File Latch to Fit

TACOM is authorizing armorers to file or stone the cover latch to fit.

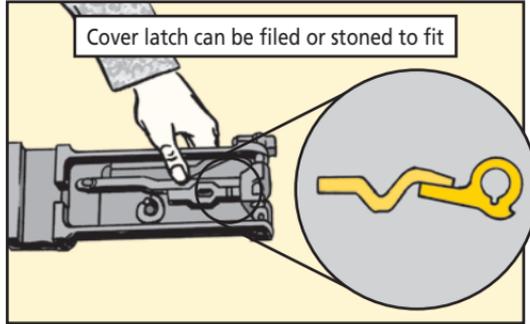
Step 3 in WP 0027 00-3 in TM 9-1005-213-23&P is being changed to read:

"Install cover latch (4) and cover latch lever (5) in subassembly cover (2). Be sure cover latch is under lip on flat spring (3). Cover latch is a File/Stone To Fit part. Remove ONLY enough material to allow cover latch to maintain the top cover clearance (0.020 inch max) check as indicated on WP 0020 00-7."
